## Bloch Wind Farm

Technical Appendix 13.1

**From:** Andy Wells <andy.wells@caa.co.uk>  
**Sent:** 17 October 2022 15:32  
**To:** Sam Johnson  
**Subject:** 20221017 Bloch Wind Farm Lighting CAA Variation Agreement

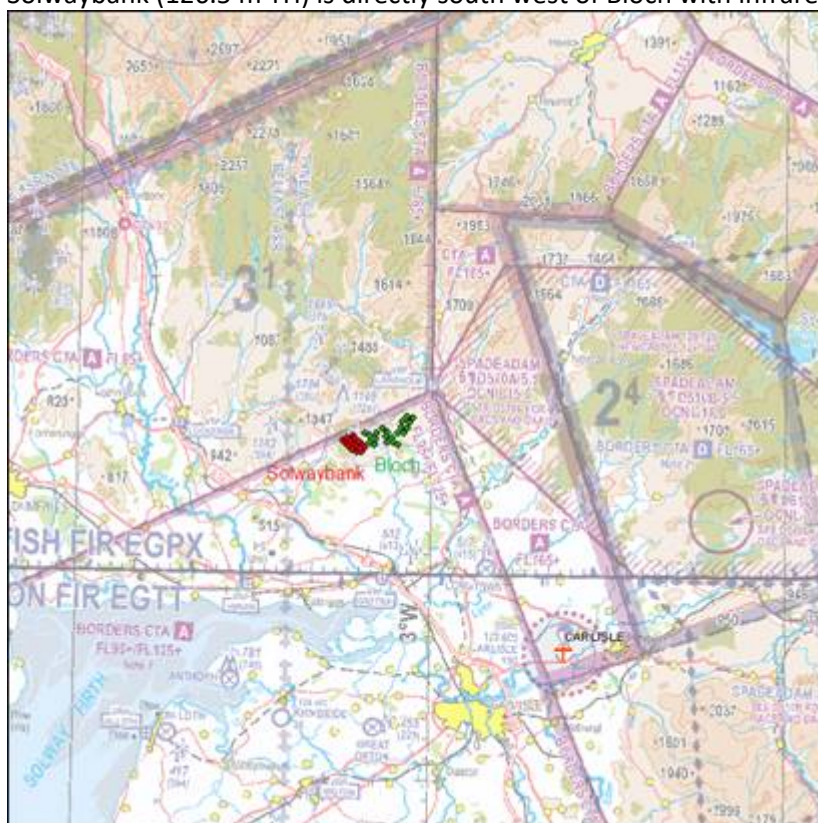
RES has a development in Scotland, Bloch Wind Farm, with proposed varying tip heights of 180 m, 200 m and 230 m tip height, which will be submitted into planning this year. Taking everything into consideration, I propose we install visible lights on all turbines except T3, T4, T9, T11, T12, T16 and T19 (as shown in the attached drawing and more information below).

- medium intensity steady red (2000 candela) lights on the nacelles of turbines T1, T2, T5, T6, T7, T8, T10, T13, T14, T15, T17, T18, T20 and T21 (fourteen turbines in total);
- a second 2000 candela light on the nacelles of the above turbines to act as alternates in the event of a failure of the main light;
- the lights on these turbines to be capable of being dimmed to 10% of peak intensity when the visibility as measured at the wind farm exceeds 5km;
- no intermediate level 32 candela lights to be fitted on the turbine towers\*

- medium intensity steady red (2000 candela) lights on the nacelles of turbines T01, T02, T05, T06, T07, T08, T10, T13, T14, T15, T17, T18, T20 and T21;
- a second 2000 candela light on the nacelles of the above turbines to act as alternates in the event of a failure of the main light;
- the lights on these turbines to be capable of being dimmed to 10% of peak intensity when the lowest visibility as measured at suitable points around the wind farm by visibility measuring devices exceeds 5km.

For this proposed development, Intermediate level 32 candela lights are not required to be fitted on the turbine towers.

**2. Relative amsl turbine tip heights of Bloch and the nearby Solwaybank Wind Farm**

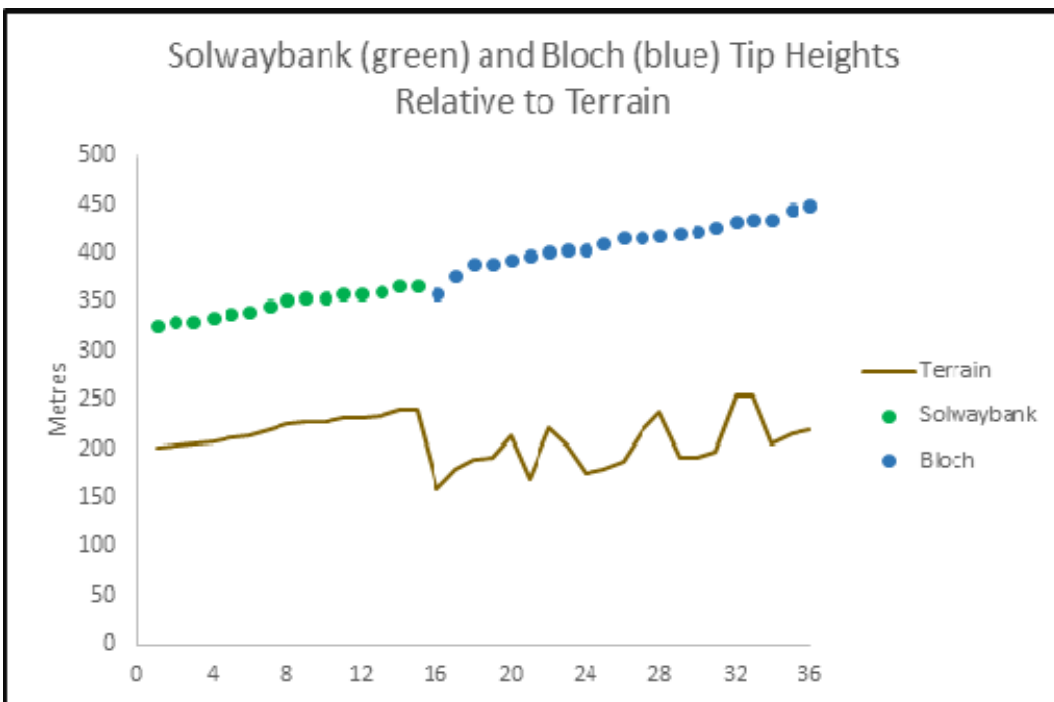
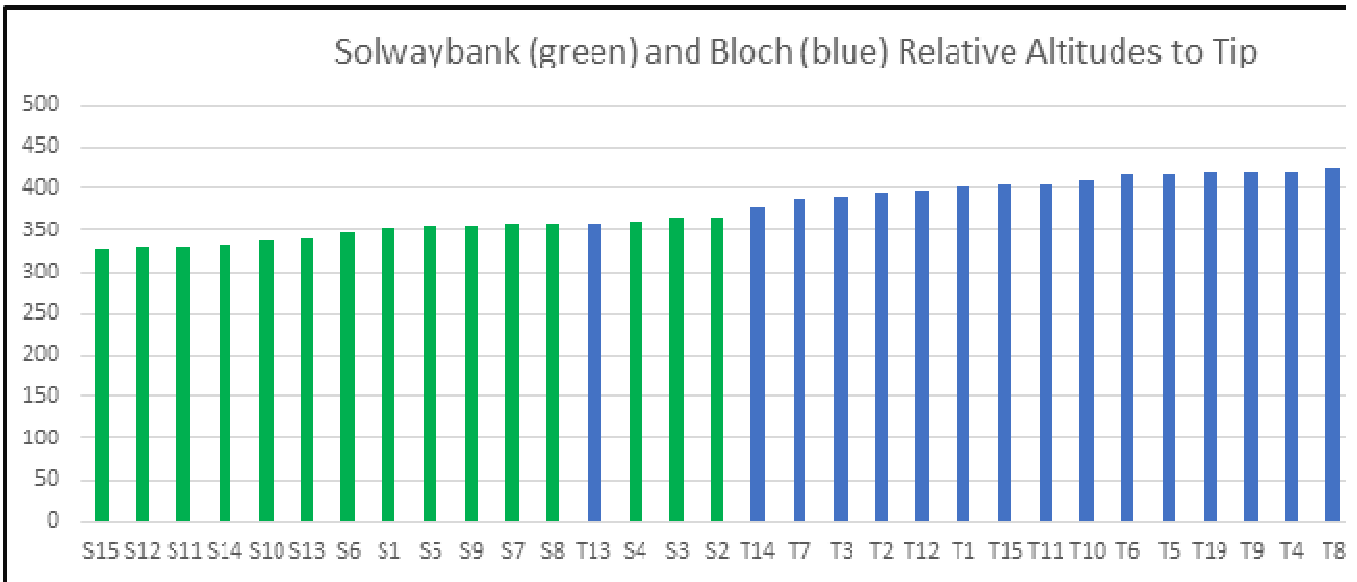
The ground levels of many Solwaybank turbines are actually higher than at Bloch and, which means that some of the turbines in each site have similar altitudes to tip.

### 3. Distance between turbines at Bloch

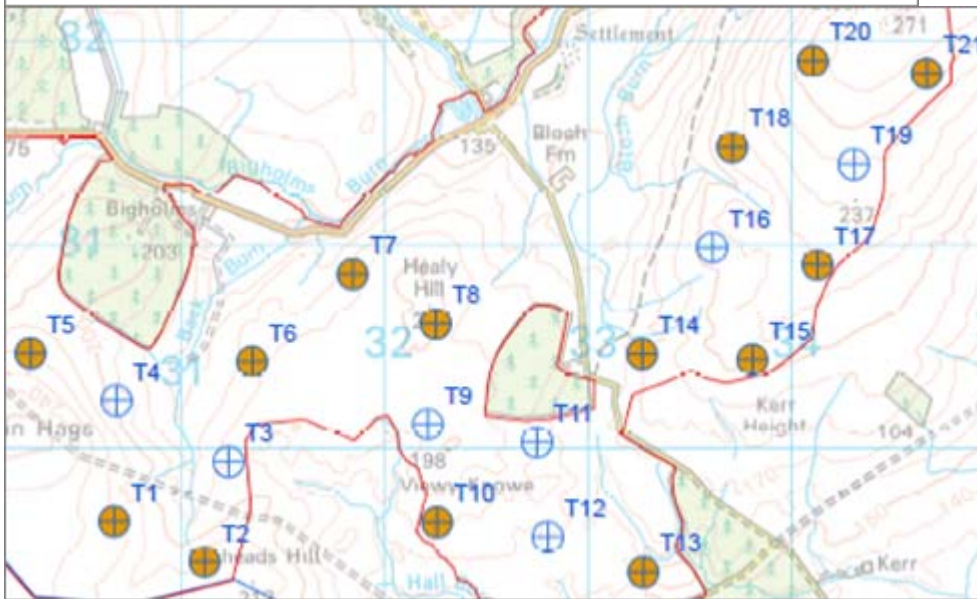
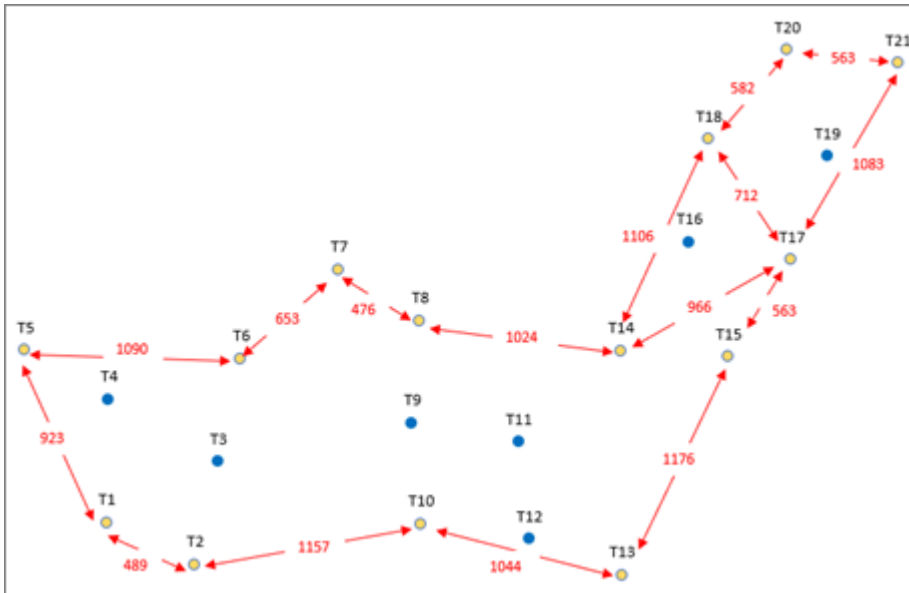
An examination was made of the relative altitudes of the Bloch tip heights and the distances between them. Ideally, perimeter turbines should be lit in a way such that there is no greater separation between turbines than 900 m, however, the layout at Bloch is such that some turbines have a larger than 900 m separation so it is not possible to adhere to this fully. Wherever possible, turbines have been placed such that either at least one turbine is less than 900 m or the distance has been kept as close to 900 m as possible. Bloch is in an area of relatively low operational significance from a civil aviation perspective with the closest airport, Carlisle, some @ 24 km from the site. The scheme suggested, I hope, provides a fair balance between impact on visual amenity and aviation safety.
